ADDENDUM # 1

BID NO.: 100167
OPENING: 10/7/15 – 3:00 PM
COMMODITY: ELECTRICAL SERVICE AND FIELD LIGHTING

NOTICE OF ADDENDUM NO. 2

University of Rhode Island
Project No. KC.M.MISC.2010.005
Public Bid No. 100167
Tibbets Athletic Fields
Kingston, Rhode Island

POLE FOUNDATION ELEV.

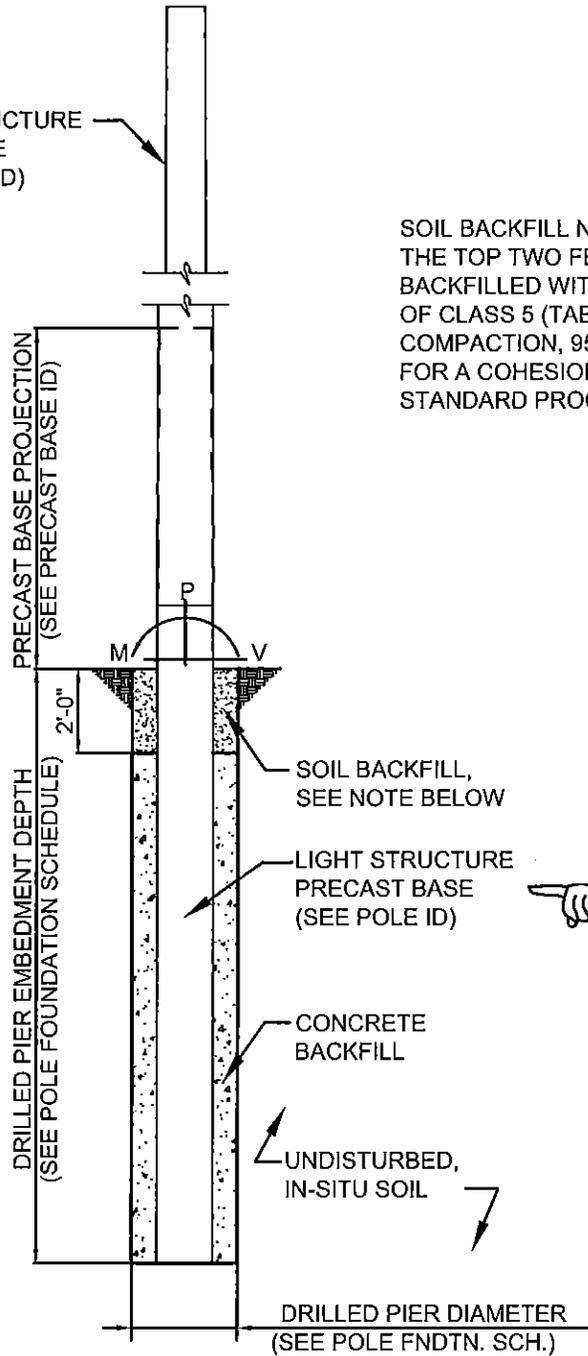
2. **Plan Sheet 4 of 7, Detail Sheet 1, Pole Foundation Elev. Detail:** Delete the detail and replace with Figure provided in Attachment 1.

SOIL BACKFILL NOTE:
THE TOP TWO FEET OF ANNULUS SHALL BE
BACKFILLED WITH SOIL, WITH A CLASSIFICATION
OF CLASS 5 (TABLE 1806.2) OR BETTER.
COMPACTION, 95% FOR COHESIVE SOIL AND 98%
FOR A COHESIONLESS SOIL BASED UPON
STANDARD PROCTOR TESTING (ASTM D698).
